Change in Wafer Fabrication Facility for XC95288XL and XC9536XL CPLDs

XCN05015 (v1.0) October 3, 2005

Product/Process Change Notice

Figure 1: Package Topmark Showing Fab Codes

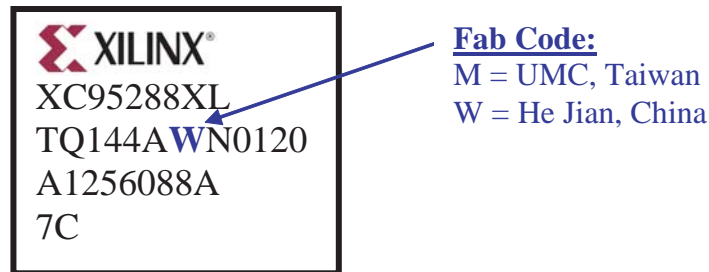
These devices can be distinguished by the second letter in the three-letter code located in the middle of the second line of the package topmark. The second letter is “W” for product fabricated at He Jian, and “M” for product fabricated at UMC. Please refer to the diagram below.
